**DCE MEMORANDUM 16-14**  
*(FHWA Approved: 7/21/2014)*

**SUBJECT:** CORRECTION TO DESIGN STANDARD, INDEX 11860, SHEET 4

CONNECTION AND WIND BEAM

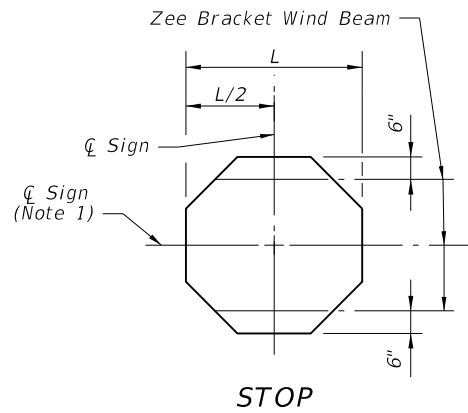
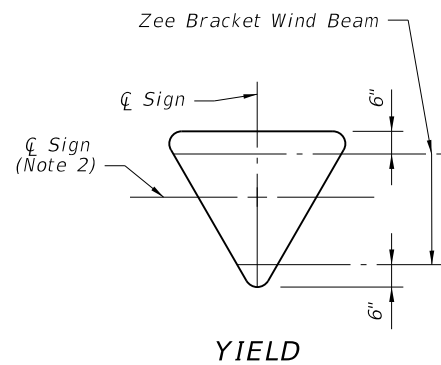
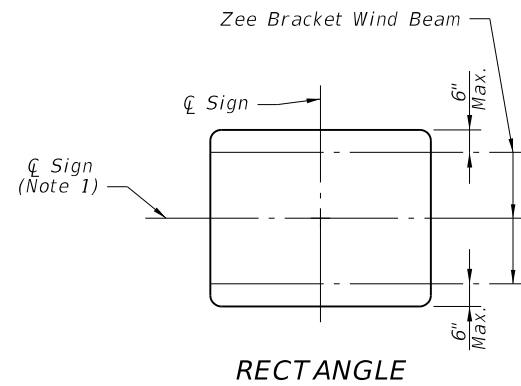
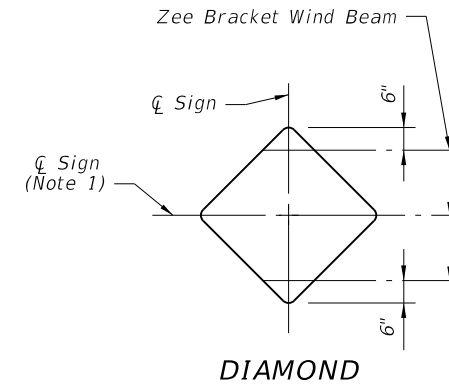
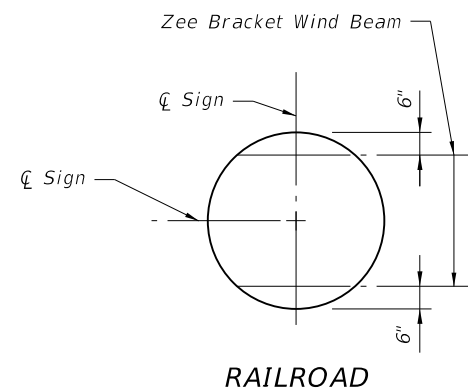
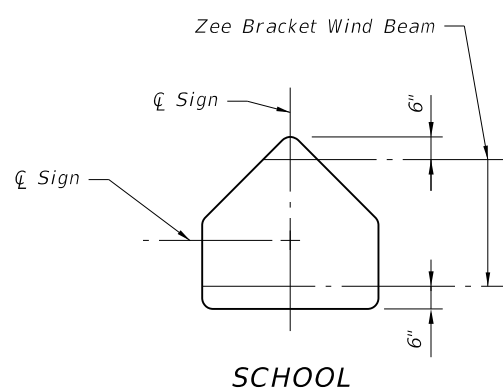
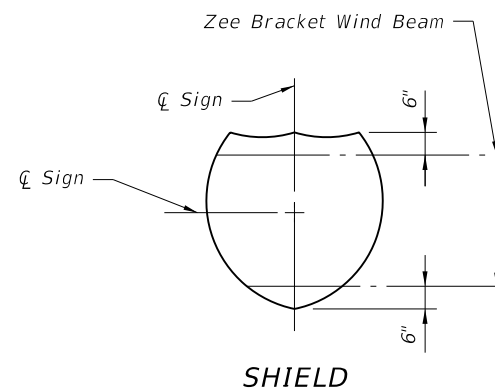
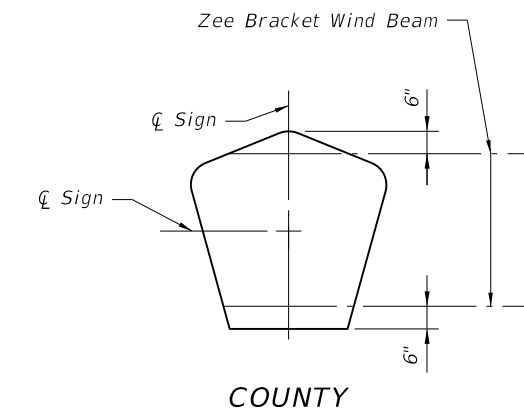
The current Design Standards, Index 11860, Sheet 4, requires a third zee bracket when either dimension of the sign panel is greater than 30". Attached is revised Design Standard, Index 11860, Sheet 4 that modifies this language and only requires a third zee bracket when the sign height is greater than 30".

For projects impacted by this correction, replace Index 11860, Sheet 4 with the attached Design Standard revision. This memorandum serves as a blanket approval to process a \$0.00 contract change and should be attached to the Work Order or Supplemental Agreement.

1. For signs with heights greater than 30" a third zee bracket wind beam shall be installed along the centerline.
2. For Yield signs greater than 36" a third zee bracket wind beam shall be installed along the centerline.
3. Use only one Wind Beam at centerline for sign height up to 12".
